**Research Report
KTC-93-30**

**VISUAL OBSERVATIONS OF PARKING AND DRIVING AREAS AND
DRAINAGE CONDITIONS ON COLVERFIELD LANE
FORT WRIGHT TRACE, FORT WRIGHT, KY.**

November 1993

Figure 12

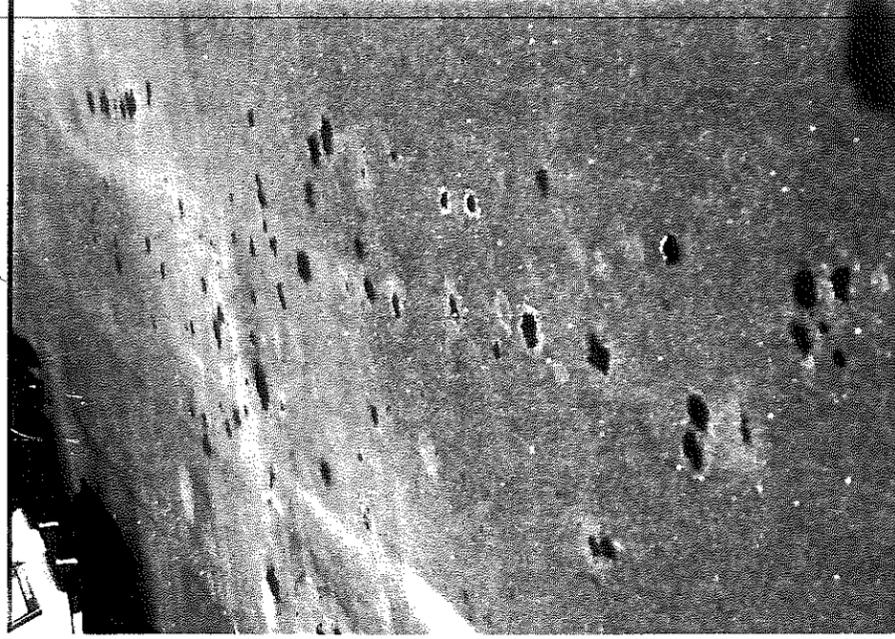
Figures 12 through 16 show where water is seeping through the asphalt layers in locations that are not associated with the construction joint between the curb and the asphalt pavement. The light-colored stains associated with the seepage in Figures 12 through 14 appear to be fine-grained material flushing or pumping up through the asphalt layers from the subgrade. Figure 15 shows some darker brown staining. This may indicate that the water that is seeping through the asphalt is emulsifying (dissolving into the water) the asphalt binder or cement used in the asphalt mixture.

Figure 16

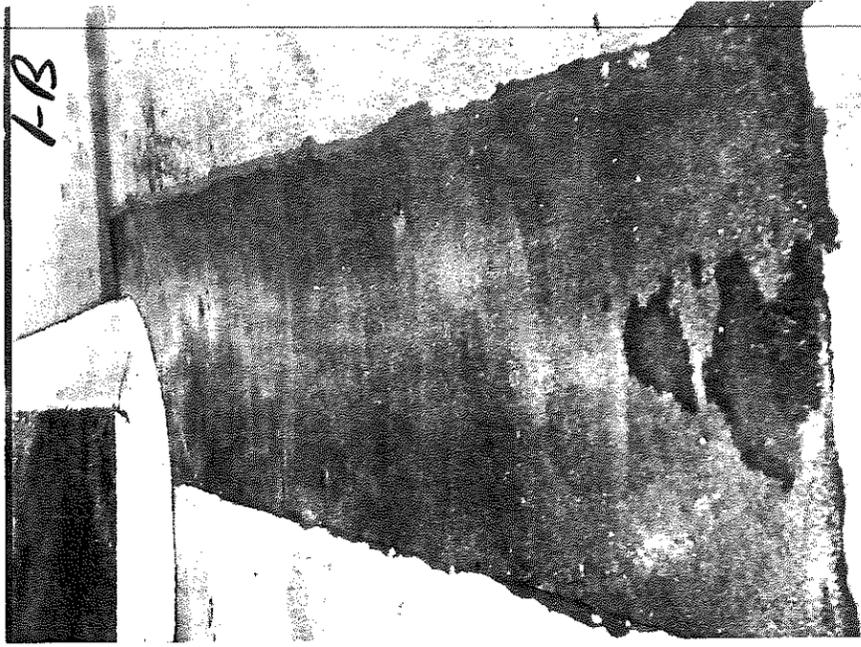
Figure 16 shows a patch located right of Station 2+25 on Cloverfield Lane. Water is also seeping under this patch, and the surface of the patch has sunk.

Figure 22

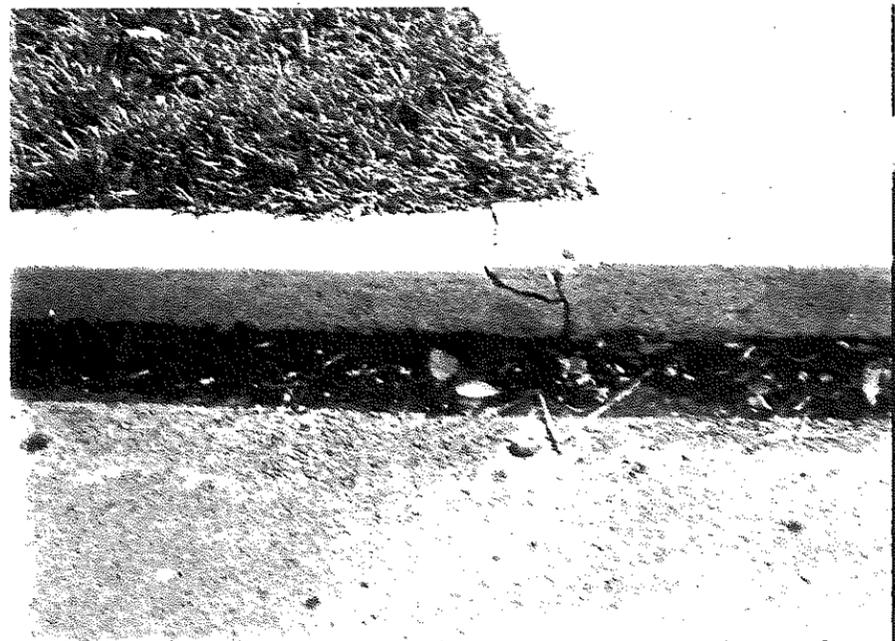
The typical section for Cloverfield Lane indicated the concrete box curb was to be constructed on top of the final asphalt base course. The owners' representatives said the curb had been constructed on the soil. Although the author did not attempt to definitely confirm this, in one location, soil did appear to be in contact with the base of the curb. From Station 2+25 to approximate Station 5+00, joints had not been sawn into the concrete curb. The results of this failure to do so are shown in Figure 22.

6. The concrete curb should be scored to control cracking.

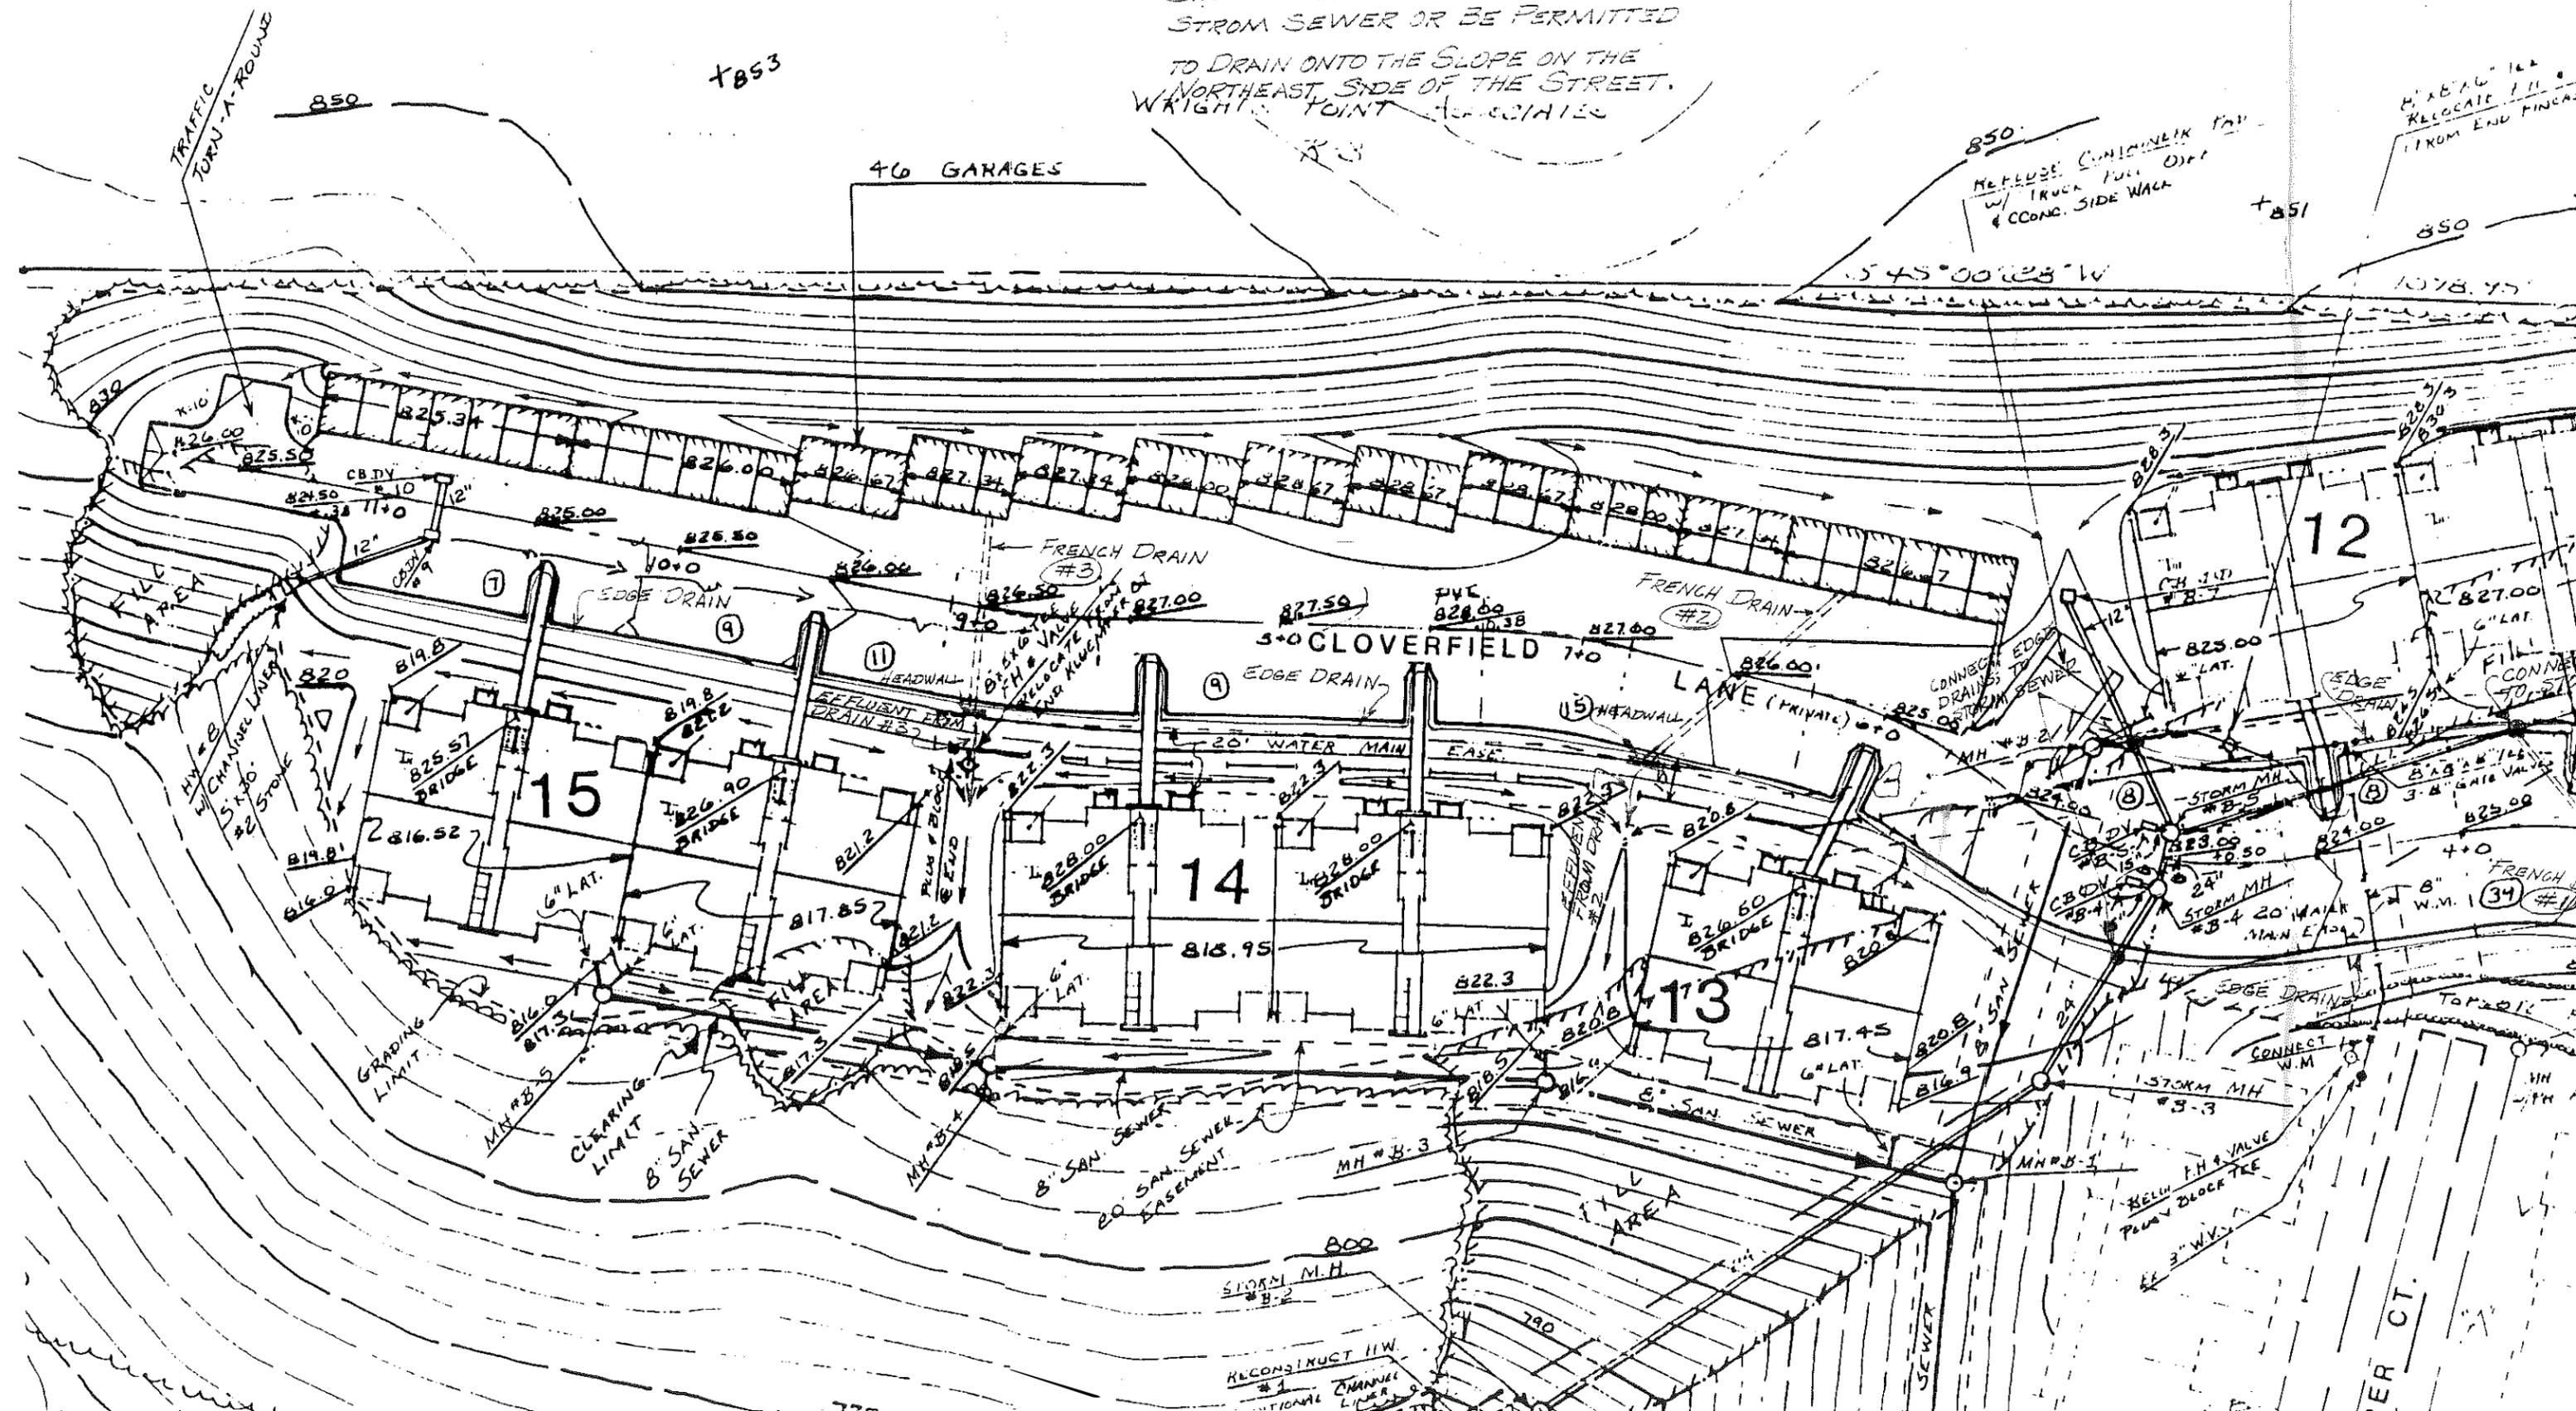
2. Panel edge drains should be installed immediately behind the concrete curb for the entire length of Cloverfield Lane. The recommended locations are shown as solid red lines on the attached sketch. These edge drains would help eliminate the seepage of water at the joint between the curb and the pavement. I have attached an informational brochure describing panel edge drains (this is not an endorsement of a particular brand).

3. To help alleviate the surface water problems, it is recommended that three French drains be installed at the locations marked by dashed red lines on the attached sketch. The effluent from these drains should be directed as shown on the sketch.

NOTE: ALL PROPOSED EDGE DRAINS SHOULD DRAIN TO THE NEAREST STORM SEWER OR BE PERMITTED TO DRAIN ONTO THE SLOPE ON THE NORTHEAST SIDE OF THE STREET. WRIGHT POINT ASSOCIATES
